MONTGOMERY COUNTY HISTORIC PRESERVATION COMMISSION
STAFF REPORT

Address:	7314 Willow Avenue, Takoma Park	Meeting Date:	4/10/2019
Resource:	Contributing Resource Takoma Park Historic District	Report Date:	4/03/2019
Applicant:	Kathy Milton Rick Vitullo, Architect	Public Notice:	3/27/2019
Review:	HAWP	Tax Credit:	Partial
Case Number:	37/03-19R	Staff:	Dan Bruechert
PROPOSAL: Window Installation and Retaining Wall Construction

Figure 1: 7314 Willow Ave.

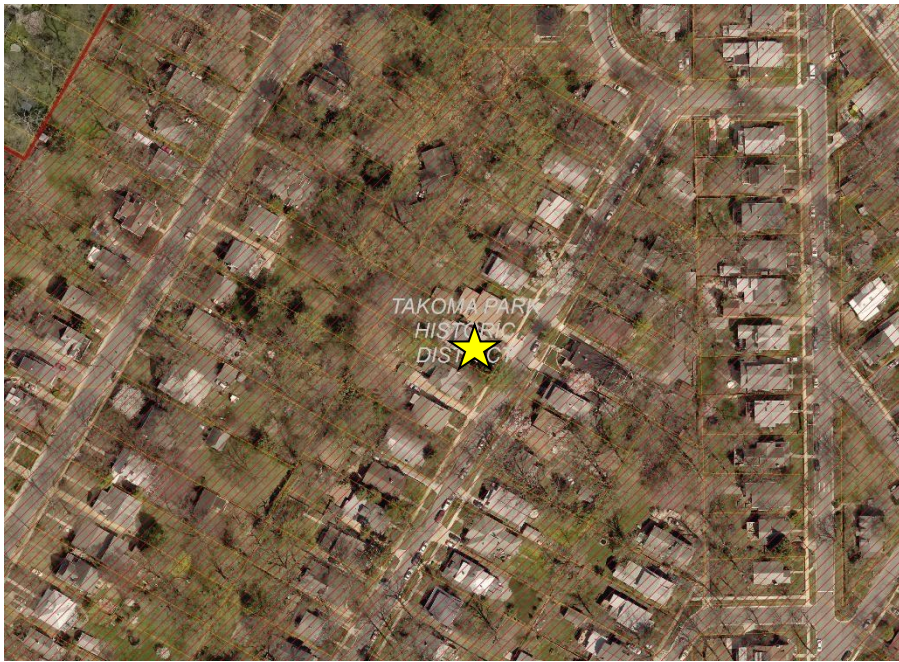
The work proposed in this HAWP will largely not be visible from the public right-of-way and will not alter the historic character of the house and surrounding district and Staff recommends

EXISTING
REAR ELEVATION
1/4"

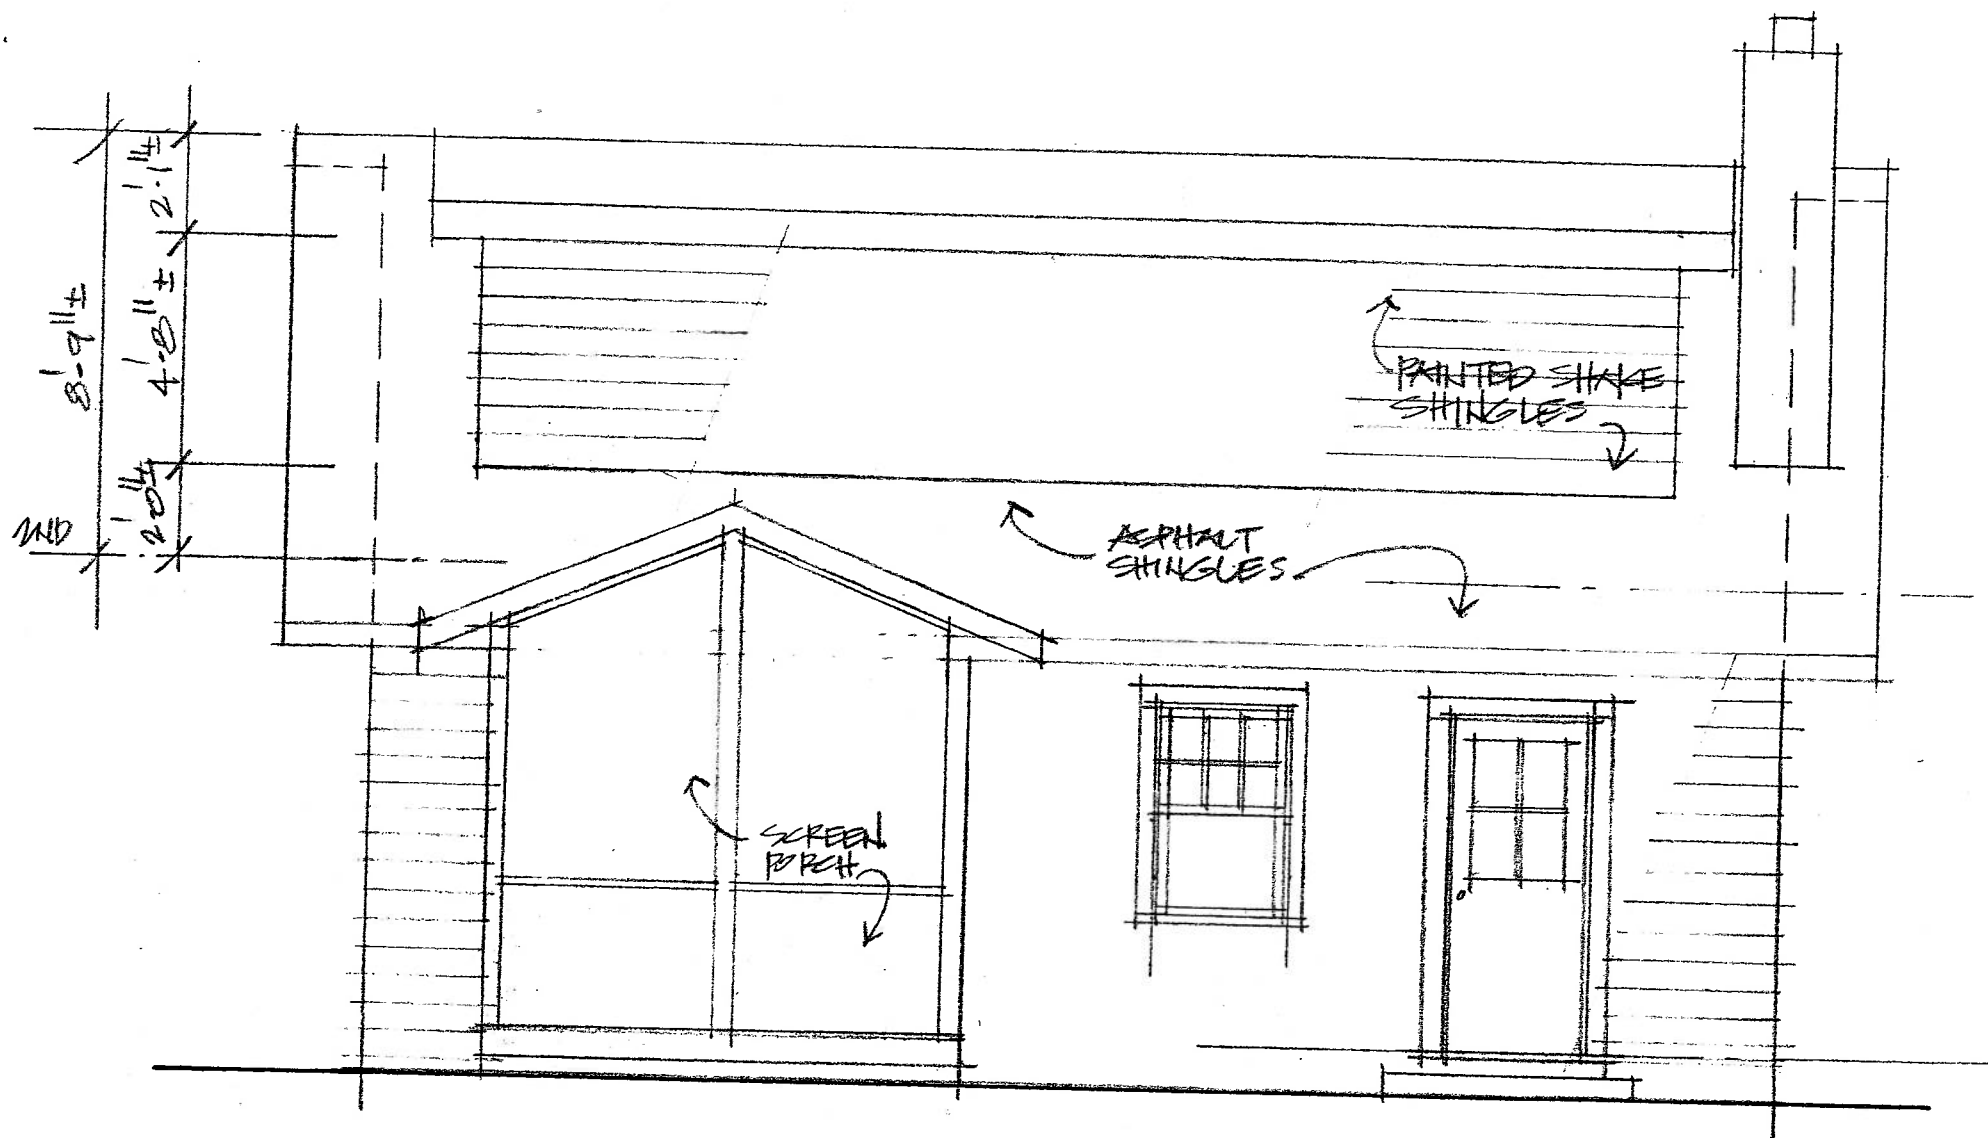
In 2007 dormers were added to the house after a tree fell on it and damaged the roof. The applicant proposes to install two pairs of six-lite, wood casement windows to the rear of this non-historic dormer.

These windows will not be visible from the public right of way and are proposed for a non-historic element. Staff finds the material of the proposed windows and configuration to be compatible and recommends approval under the *Guidelines* and 24A-8(b)(2).
